Subject: FW: Complaint 10668373
Date: Tuesday, January 13, 2015 11:05:58 AM
Attachments: [Catastrophic Failures of Interior Door Handle on 1998.pptx](#)

From: [REDACTED]
Sent: Monday, January 12, 2015 8:35 PM
To: DataQuality, DataQuality (NHTSA)
Subject: Complaint 10668373

Catastrophic Failures of Interior Door Handle on 1998 GMC Sierra

Exhibit of Fractures

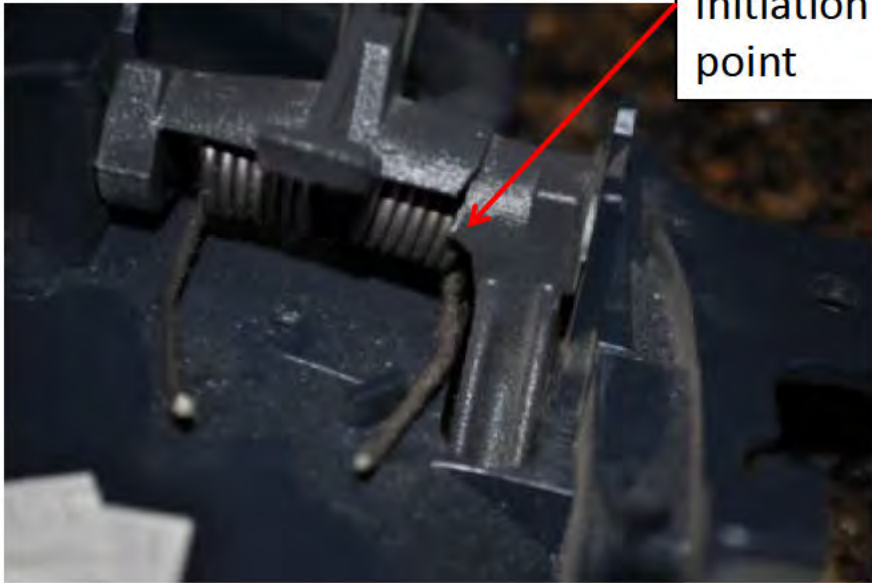
Fracture
initiation
point

Fracture
initiation
point

Exhibit of Fractures

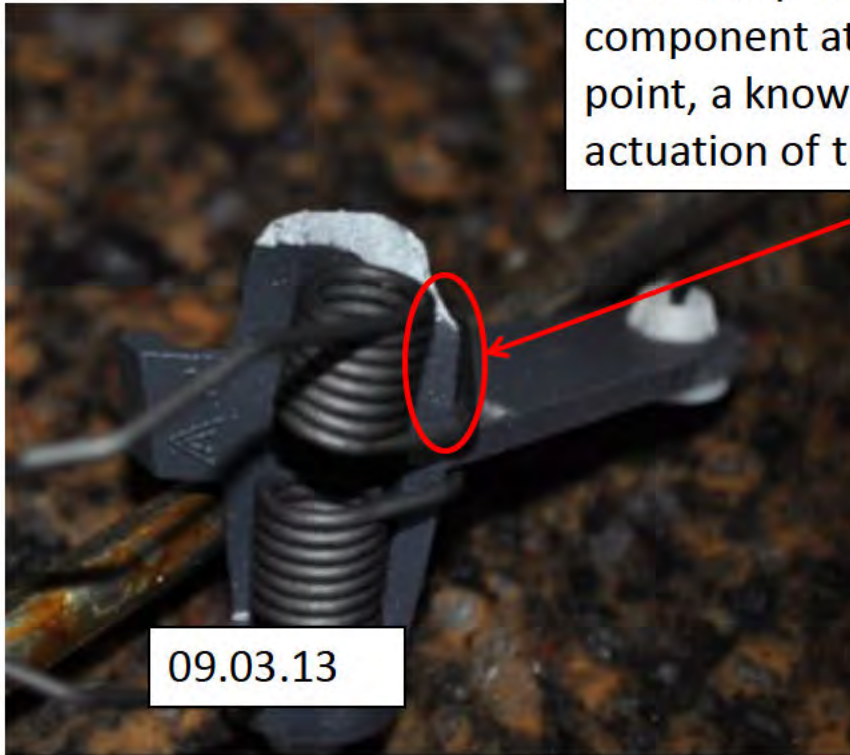
Note sharp feathered edge on component at fracture initiation point, a known stress point during actuation of the door handle.

Exhibit of Fractures

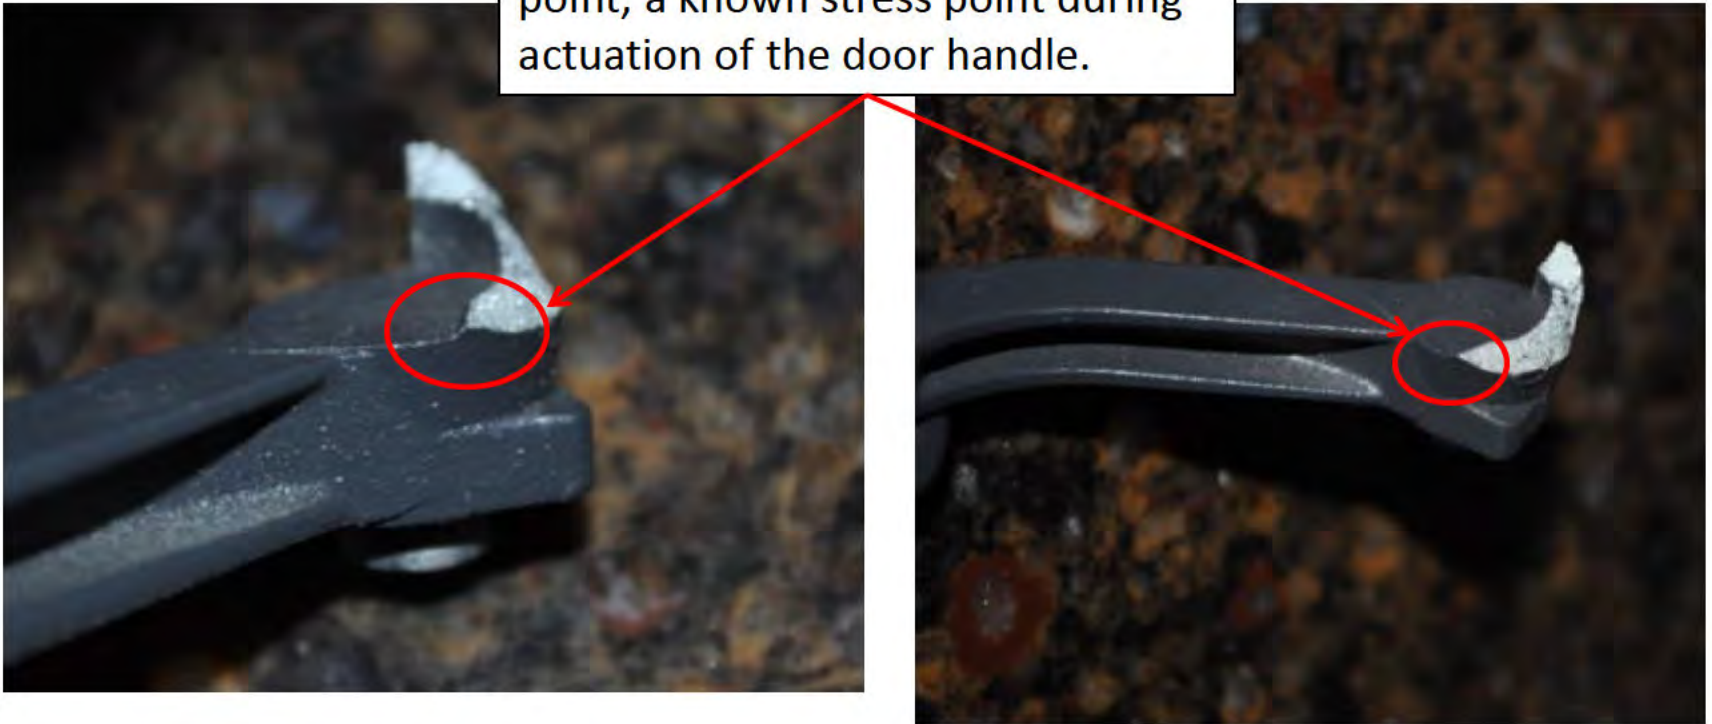
Note feathered edge on component at fracture initiation point, a known stress point during actuation of the door handle.

Powder Metal Design Principles

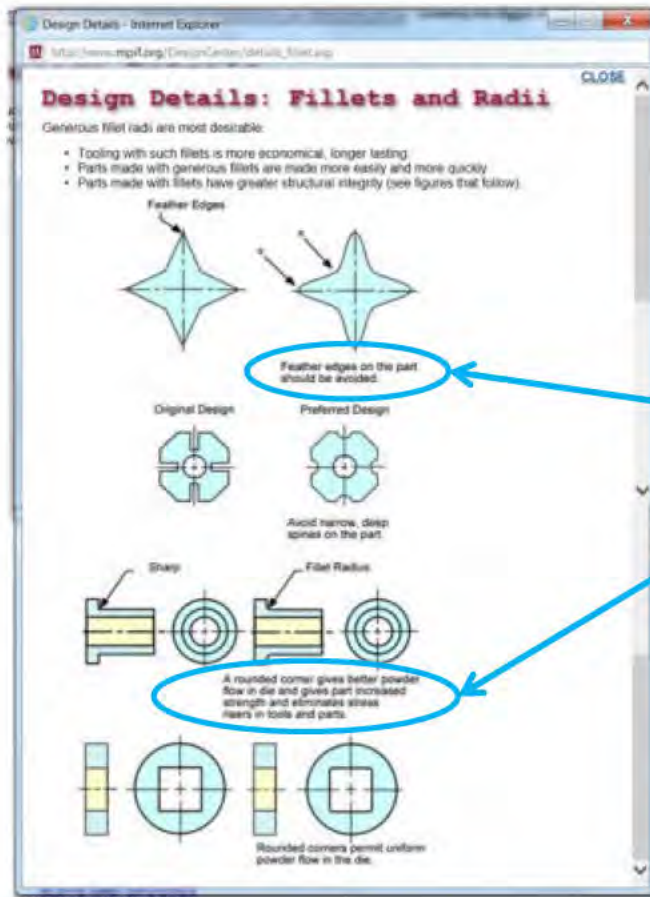
Features must be avoided that require tools with thin, weak sections or sharp inside corners, cause problems in powder fill and compaction, or make the component prone to distortion during sintering. Here are some of those problem features along with acceptable alternatives.

Note that sharp corners are undesirable and should be designed with a fillet radius.
